**ADDENDUM TWO**

**2025 Roofing Work at Sand Creek Elementary for:  
Jennings County School Corporation**  
34 W Main Street  
North Vernon, Indiana 47265

Commission No.: F25083  
Addendum Date: November 7, 2025

**ADD 1**

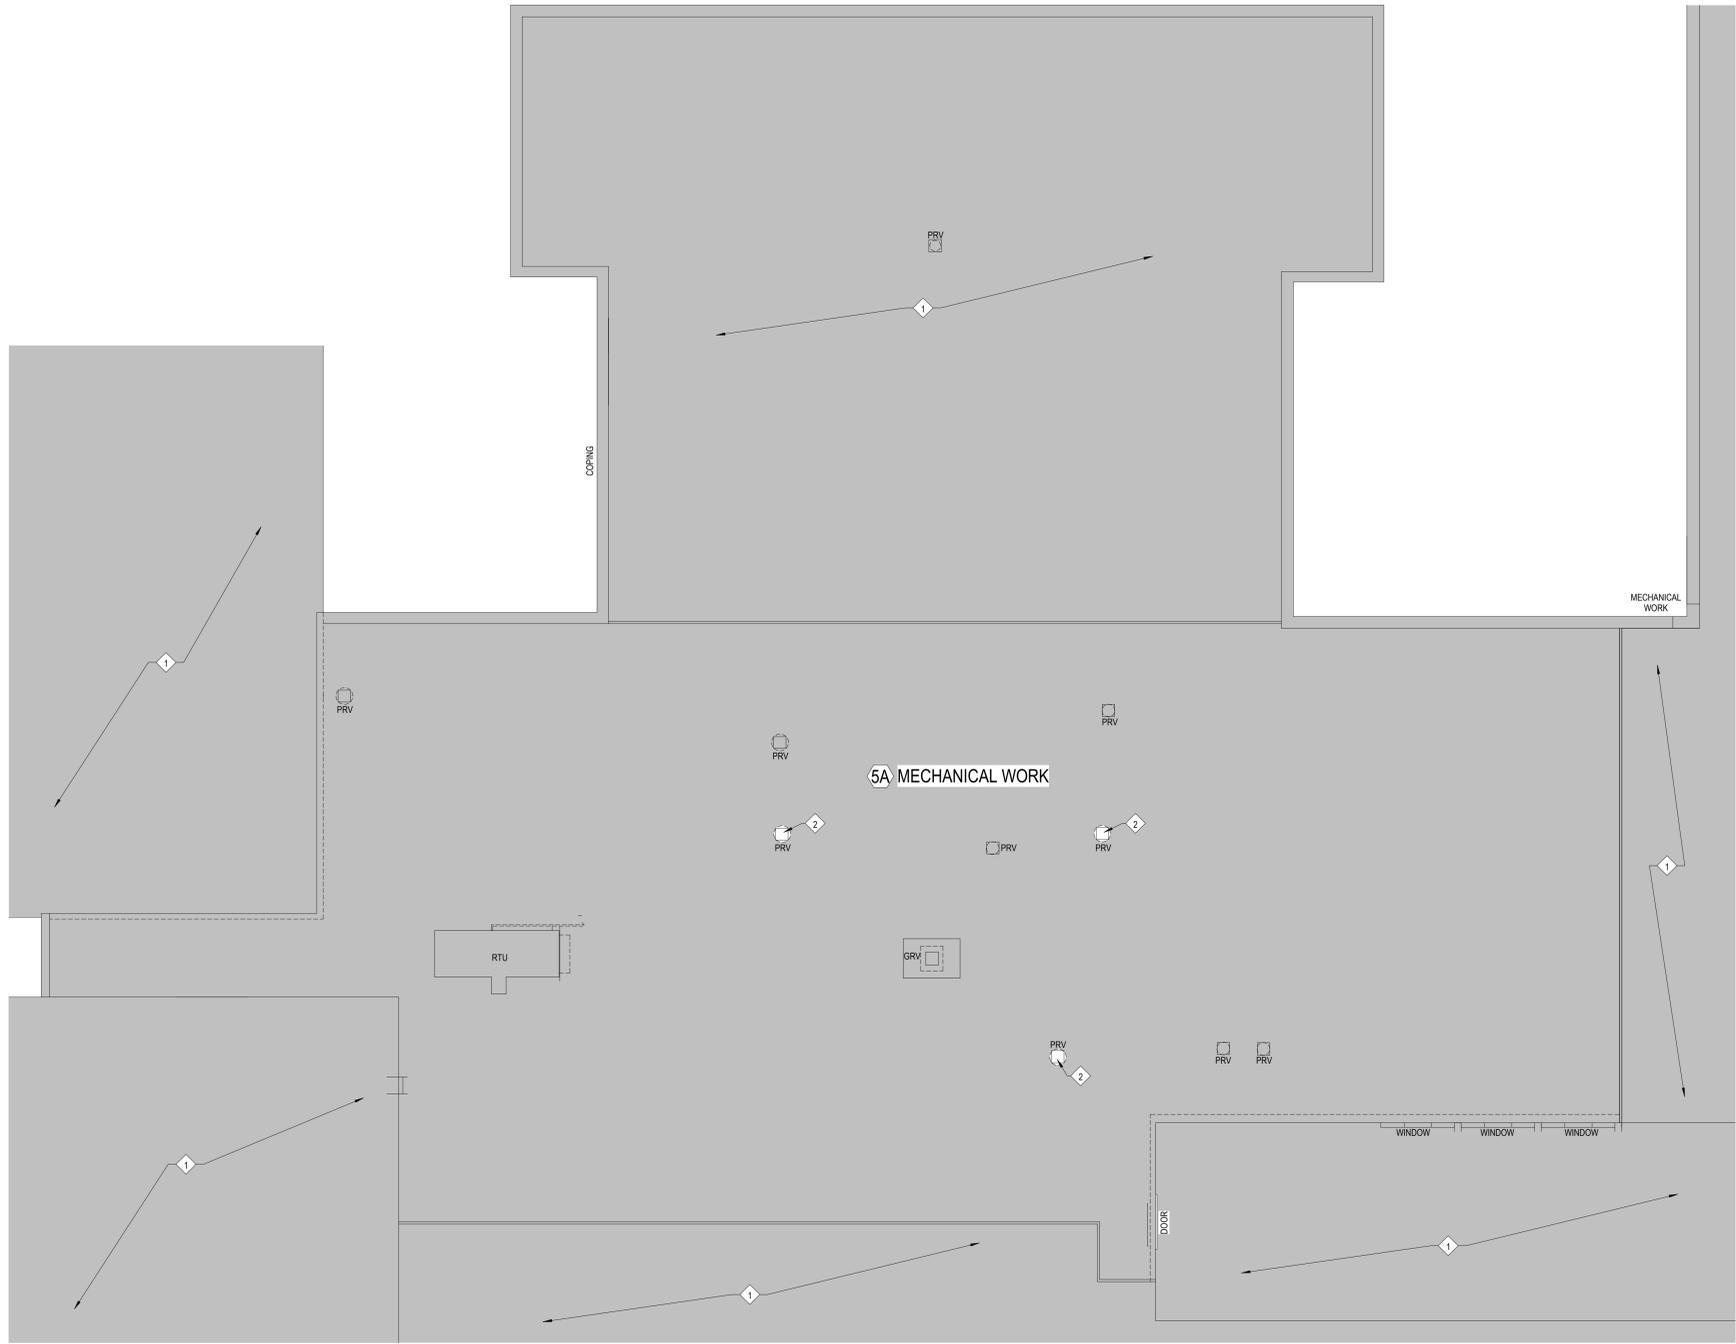
Sheet ADD 1 - Partial Roof Plan - N.I.C - **ADD** new sheet attached at the end of this Addendum Two:

- a. **ADD** - Detail Work Description Note #22 - EXISTING POWER ROOF VENTILATOR CURB TO REMAIN AT EXISTING HEIGHT. REPLACE EXISTING POWER ROOF VENTILATOR MECHANICAL UNIT WITH COOK ACE-D DOWNBLAST CENTRIFUGAL ROOF MOUNTED/DIRECT DRIVE EXHAUST VENTILATOR, CATALOG NUMBER 100C15DH, AREA 5C - SEE DETAIL 3/ADD 1
  - a. (3) PRV mechanical units have been noted on the roof plan to be replaced with the noted mechanical unit.

- ◇ Plan Work Description Notes - Addendum
- 1 NO WORK AND OR MATERIALS TO BE STORED/PERFORMED IN THIS AREA
  - 2 EXISTING POWER ROOF VENTILATOR CURB TO REMAIN AT EXISTING HEIGHT. REPLACE EXISTING POWER ROOF VENTILATOR MECHANICAL UNIT WITH COOK ACE-D DOWNBLAST CENTRIFUGAL ROOF MOUNTED/DIRECT DRIVE EXHAUST VENTILATOR, CATALOG NUMBER 100C15DH, AREA 5A - SEE DETAIL 3/ADD 1

**1 Roof Plan**  
1/8\"/>

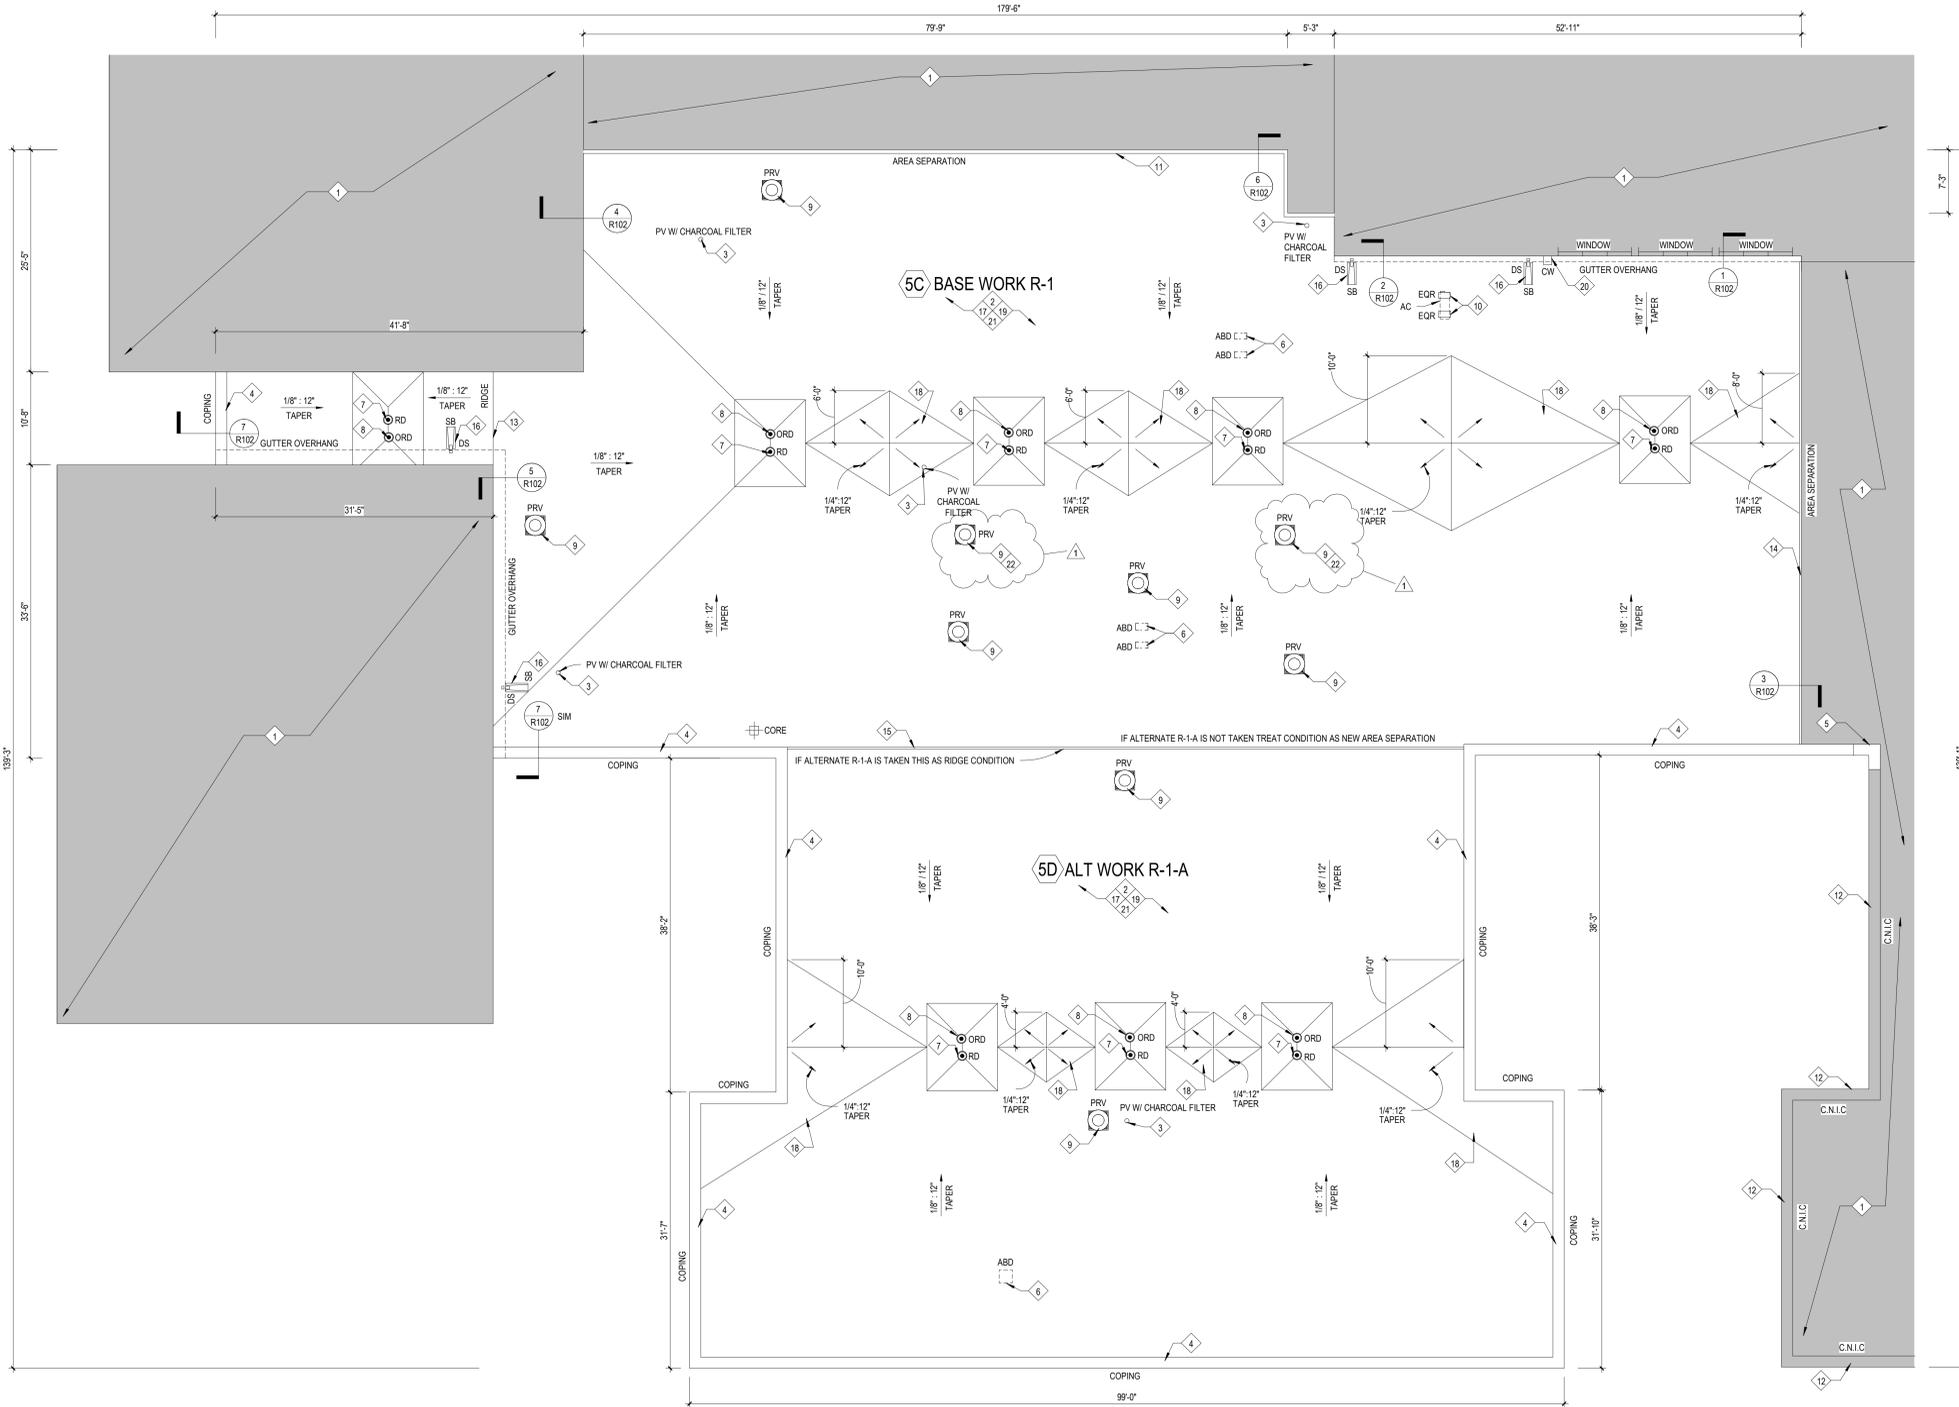
Sheet R101 - ROOF PLAN - **REMOVE AND REPLACE** Sheet R101 ROOF PLAN with new updated sheet R101 ROOF PLAN attached at the end of this Addendum Two:

- a. 1/R101 - Roof Plan - **ADD** - Detail Work Description Note #22 - EXISTING POWER ROOF VENTILATOR CURB TO REMAIN AT EXISTING HEIGHT. REPLACE EXISTING POWER ROOF VENTILATOR MECHANICAL UNIT WITH COOK ACE-D DOWNBLAST CENTRIFUGAL ROOF MOUNTED/DIRECT DRIVE EXHAUST VENTILATOR, CATALOG NUMBER 100C15DH, AREA 5C - SEE DETAIL 3/ADD 1
  - a. (2) PRV mechanical units have been noted on the roof plan to be replaced with the noted mechanical unit.

- PROVIDE NEW CONTRACTOR'S WARRANTY (2 YEAR) AND MANUFACTURERS WARRANTY (30 YEAR). AREA <SC> AND <SD>
- EXISTING POWER ROOF VENTILATOR CURB TO REMAIN AT EXISTING HEIGHT. REPLACE EXISTING POWER ROOF VENTILATOR MECHANICAL UNIT WITH COOK ACE-D DOWNBLAST CENTRIFUGAL ROOF MOUNTED/DIRECT DRIVE EXHAUST VENTILATOR, CATALOG NUMBER 100C150H, AREA 5C - SEE DETAIL 3A001
